STAFF REPORT TO THE DESIGN REVIEW COMMITTEE

Permit Type: Design Review and Conditional Use

File No. Z0160-25 and Z0161-25

Applicant's Proposal: The applicant proposes to build a 42-bed residential care facility with 24-hour care for elderly tenants. The care facility will also include a memory care endorsement. The development will include associated on-site landscaping, lighting, and parking.

Landscaping Plan

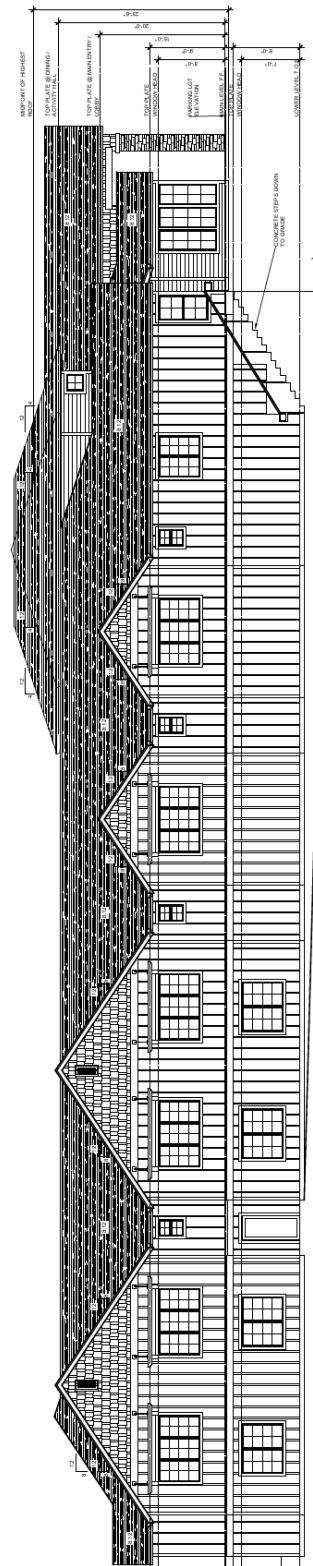
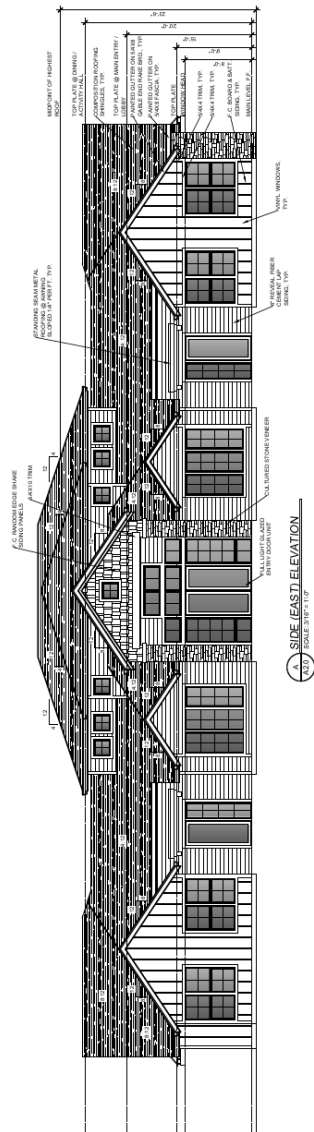
Finding: The minimum required landscaped area is 25% for conditional uses in the R-10 zoning district. The subject property is 49,058 square feet, therefore a minimum of 12,265 square feet of landscaping is required. The development plan results in 47% of the site remaining undeveloped; the applicant proposes to plant 12,743 square feet of landscaping.

Turf lawn may comprise a maximum of 10% of the minimum landscaped area required, which equates to a maximum of 1,226.5 square feet. The applicant proposes 1,639 square feet of turf area, but only 1,226.5 square feet of the turf can “count” towards the minimum requirement. The proposal meets the minimum amount of landscaping required.

The landscaping plan submitted demonstrates that a variety of plants will be provided, and at least 75% will be drought-tolerant or native. A concrete retaining wall abuts the parking spaces and is in front of a 5-foot side landscaping strip between the parking lot and the adjacent property. One tree is proposed every 30 feet along the perimeter parking spaces to comply with the minimum requirements. Subsection 1009.03(B)(2) requires the wall to be at least 3 feet tall if shrubs are not going to be provided; if approved, a condition of approval is warranted to ensure compliance with this criteria. Due to the subjective nature of Subsection 1009.03(B)(2), if the applicant would rather install shrubs to satisfy this code section instead of a 3-foot tall retaining wall, the landscaping plan should be updated in advance of a land use decision. A 6-foot cedar fence surrounding the rear and sides of the property and a trash enclosure is proposed to screen the garbage and recycling receptacles. These standards are met.

5. The retaining wall shall be a minimum three feet in height along the northern/northeastern (side) property line to meet the perimeter landscaping requirements. [1009.03(B)(2)]

6. The irrigation system shall be automatic, except that hose bibs and manually operated methods of irrigation may be permitted in small landscaped areas close to buildings. Automatic irrigation systems are subject to the standards of Subsection 1009.10(M).

Figure 1 Main building entrance accessing the walkway to Thiessen Rd. that does not directly face Thiessen Rd.

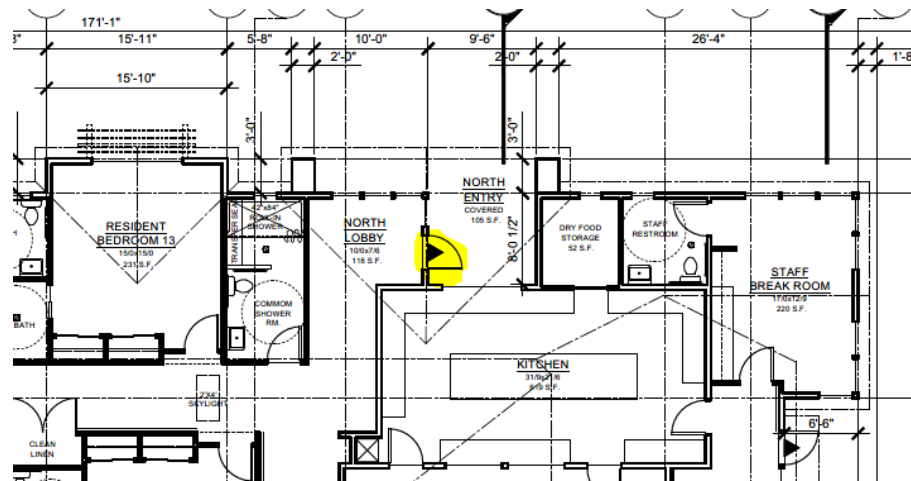
There are two primary building entrances; one faces the parking lot and the other is on the façade fronting Thiessen Rd. Each entrance is sheltered by an awning or overhang of at least 4 feet. The entrances are defined with horizontal siding and masonry, which differs from the rest of the building. Subsection 1005.03(B) requires

public entrances be clearly defined and highly visible, and if the building is sited to comply with 1005.02(E) institutional buildings (including a nursing home) must have a public entrance that faces the street. As explained above, the applicant is requesting a modification to 1005.02(E), and if approved then 1005.03(B)(2) would not be required. The proposed design has the entrance that connects to Thiessen Rd. not facing or visible from the street. Staff requests feedback from the Design Review Committee regarding whether that entrance is “clearly defined” and “highly visible” such that the intent of this standard is being met.

Figure 2 Space between the two recycle containers must be a minimum 4 feet.

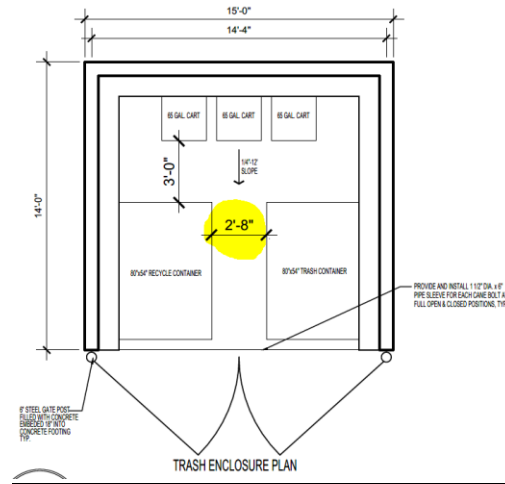
When containers face each other, a minimum 4-foot separation is required (subsection 1021.05(A)(3)). As designed, the enclosure does not meet the 4-foot spacing requirement. If the spacing cannot be met, the applicant can request modification pursuant to 1021.08. At this time, staff recommends that the applicant provide additional information regarding whether they will modify the enclosure to that it can meet the standard, or provide a modification request for staff to review.
